Research Information Letter 09-001: Preliminary Deterministic Analysis of Seismic Hazard at Diablo Canyon Nuclear Power Plant from Newly Identified “Shoreline Fault”

Figure 9. Site Shear Wave Velocity Profiles from 1978 Downhole Measurements (Figure 5-5 in DCPD LTSP Report) with Annotation by NRC Staff

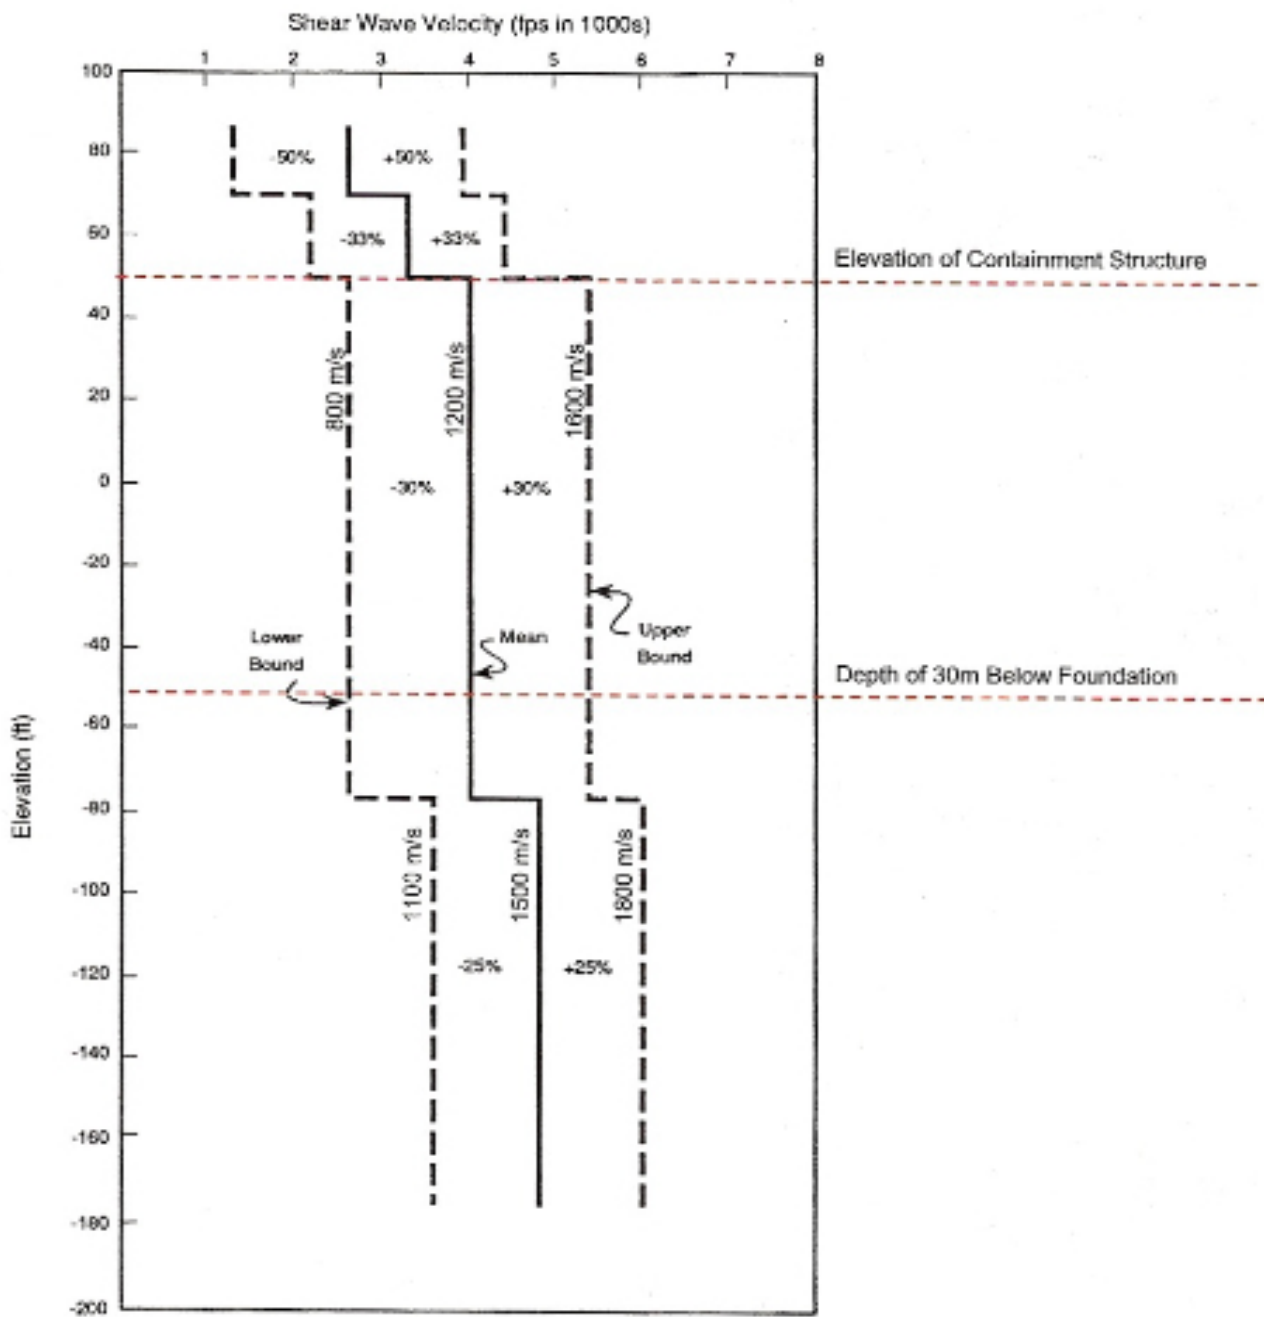
Using Figure 9, the Staff determined that the best estimate of $V_{s,30}$ at the site is 1,100 m/s and the $Z_{1.0}$ is zero¹. In this case, information to directly determine $Z_{2.5}$ was not available. For this reason, the Staff used the estimation techniques described in Campbell and Bozorgnia (2007). The equations provided (where all depths are in km) are as follows:

As noted, the depth to $Z_{1.0}$ varied from 0 to 40 m (0.04 km). Figure 9 shows that $Z_{1.5}$ (the depth to 1.5 km/s) is 0 m in the upper bound profile, is 40 m in the best estimate profile, and is undetermined in the lower bound profile. Thus, the values for $Z_{2.5}$ range from 0.03 km (the minimum value based on the bottom of the profile) to 1.4 km. Because higher values of $Z_{2.5}$ are conservative and functionally any value between 1.0 km and 3.0 km is treated the same in the GMPE, the default value of 2 km provided by Campbell and Bozorgnia was used.

Upper and lower bound analyses also were performed using the V_s profiles from Figure 9. The values used in this study are shown below. In performing their study, the licensee used a V_s of 800 m/s, which is slightly more conservative than the best estimate value used by NRC staff.

Figure 10. Comparison of Individual 84th Percentile Ground Motion Prediction Equations with Best Estimate Parameters and Diablo Canyon Review Spectrum

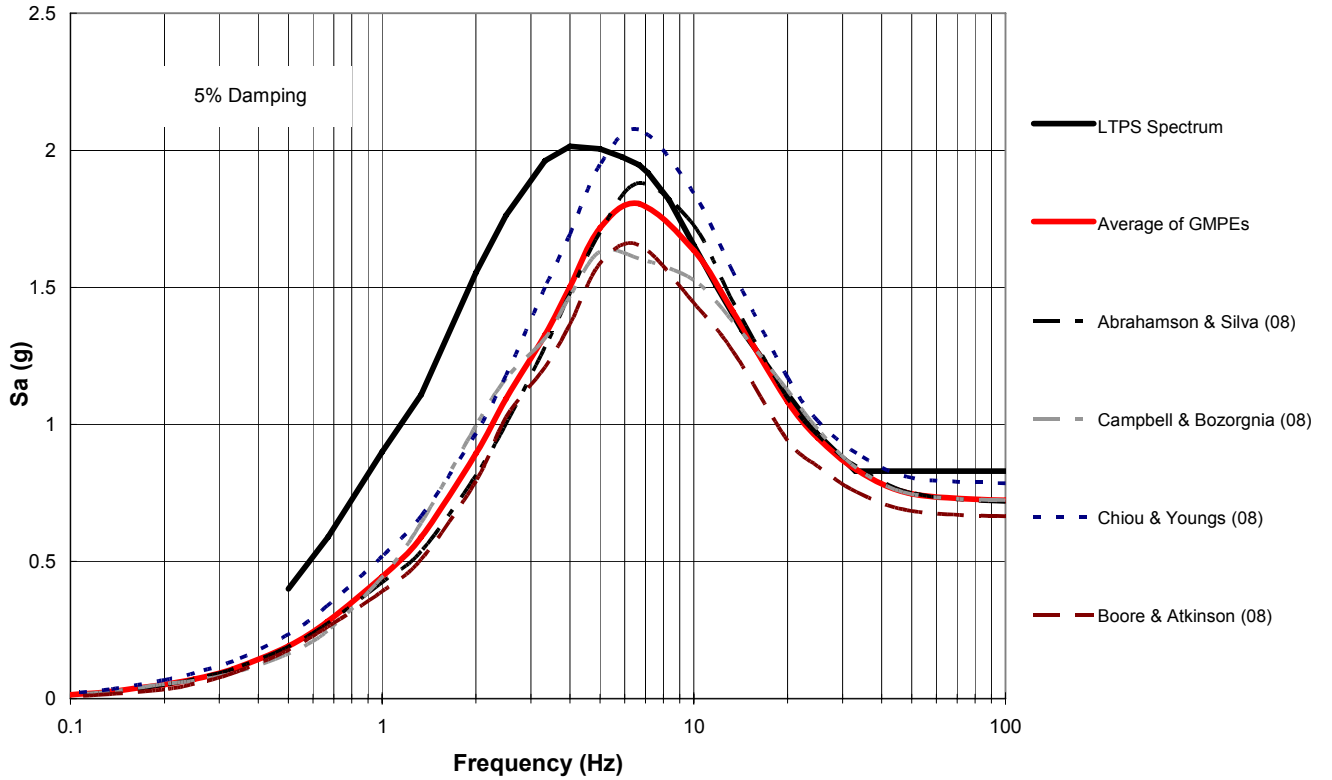
Response spectra were calculated using the four GMPEs and the parameters described above. The results were then compared to the LTSP spectrum. Figure 10 shows a comparison of the LTSP spectrum with the suite of the GMPEs using the best estimates of the 84th percentile. The results give an indication of the uncertainty associated with the GMPEs. The figure shows that the best estimate values provide an average predicted ground motion for all frequencies that is essentially at or below the LTSP spectrum for which the plant was previously analyzed. The motions are very close to the LTSP in the high-frequency range but fall below the LTSP in the long-period range. This is to be expected because the LTSP is essentially the Hosgri spectrum that was developed based on a magnitude 7.5 earthquake located farther from the site than the potential magnitude 6.4 Shoreline Fault. Figures 11 to 13 show the results of the parametric analyses for magnitude, distance, and shear-wave velocity. In the case of magnitude and distance, the range of predicted values resulting from the analyses generally remains approximately at or under the LTSP spectrum at all frequencies. This is as expected

Figure 13. Comparison of Average Results of 84th Percentile Ground Motions with Varying Site Shear Wave Velocity Profiles

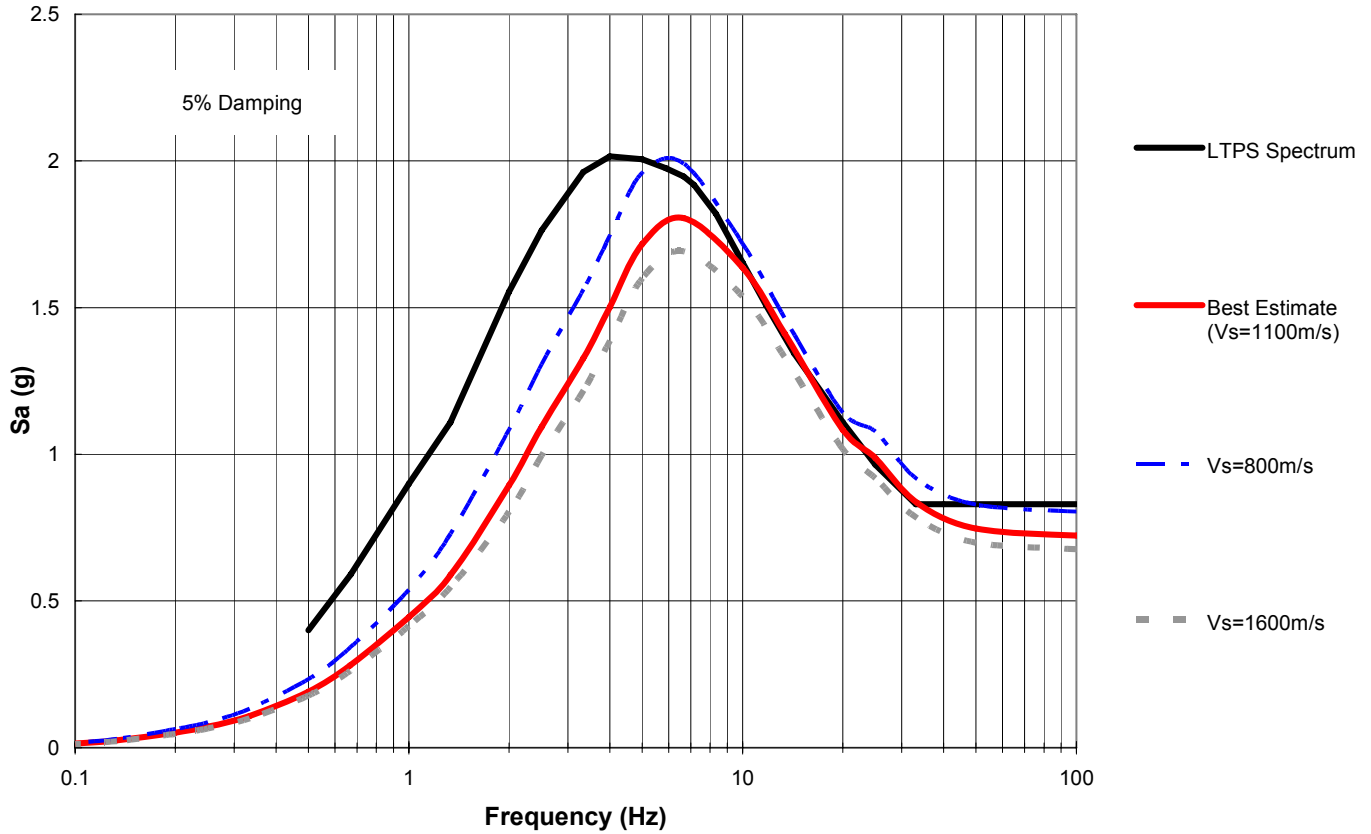
In the case of shear wave velocity, the lowest shear wave velocity profile does show greater variance from the average value and exceeds the LTSP spectrum by a small amount over some frequencies. Interestingly, this parameter relates to a property of the site, not of the fault itself. This is somewhat typical as the properties of material near the surface can have significant effect on the amplitude of the incoming waves.

Figure 14. Comparison of Spectra Developed and Provided by the Pacific Gas & Electric Company

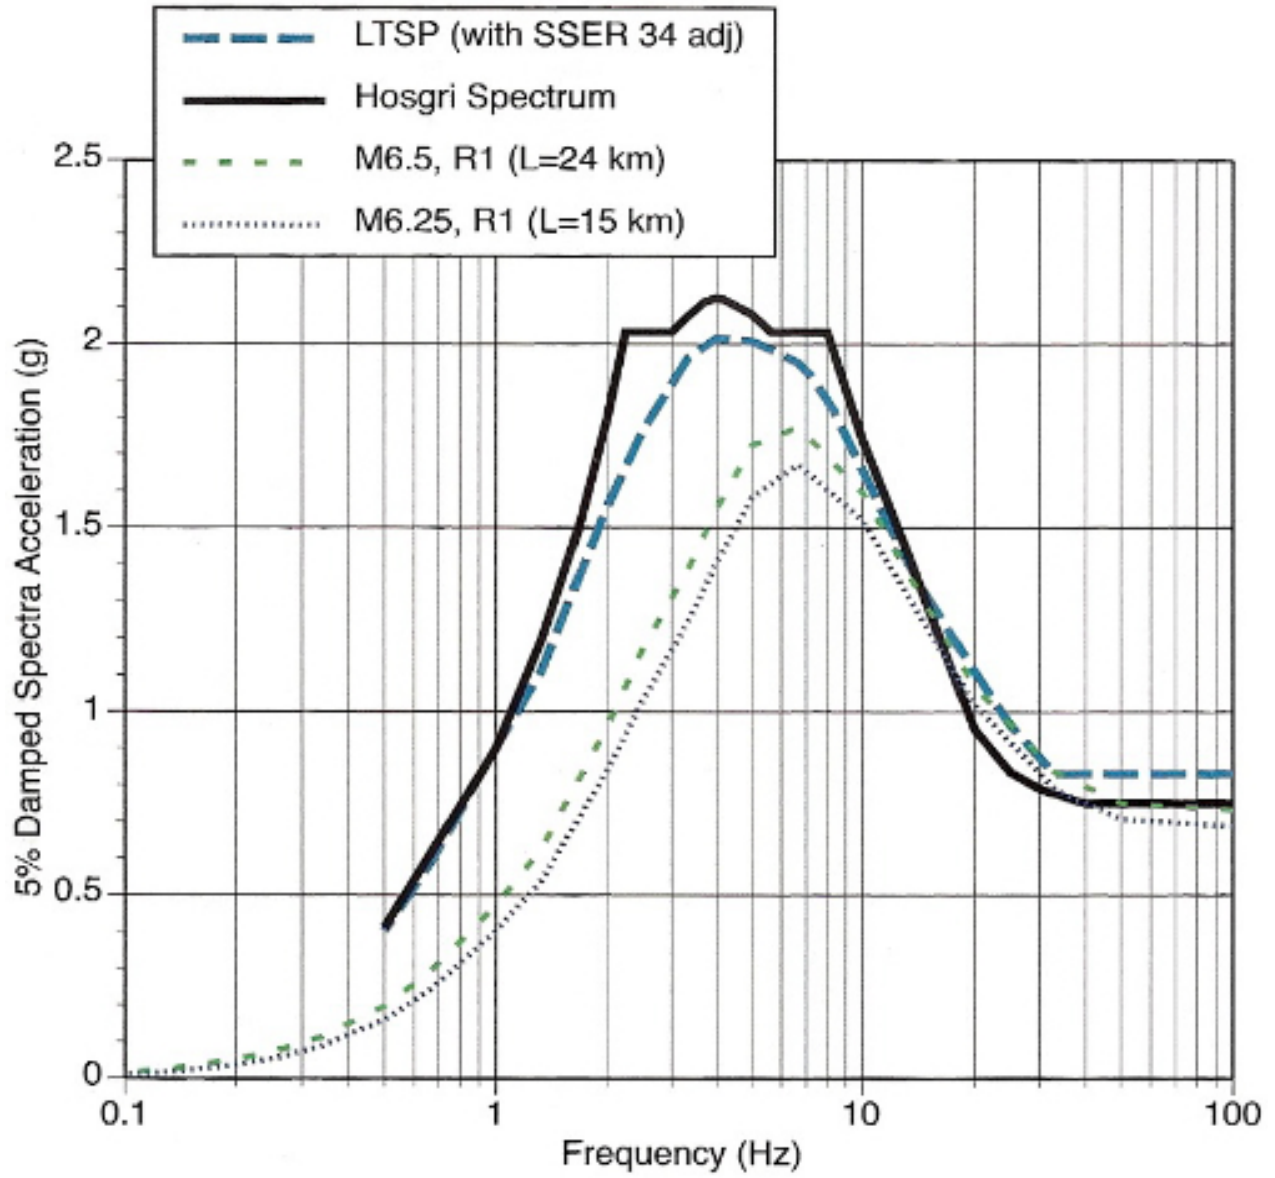
The result of the NRC analyses can be compared to those provided by PG&E, as shown in Figure 14. Generally, the two sets of analyses show similar results. This similarity is due to PG&E's use of the conservatively lower V_s estimate of 800 m/s in combination with a slightly lower magnitude for the postulated Shoreline Fault.
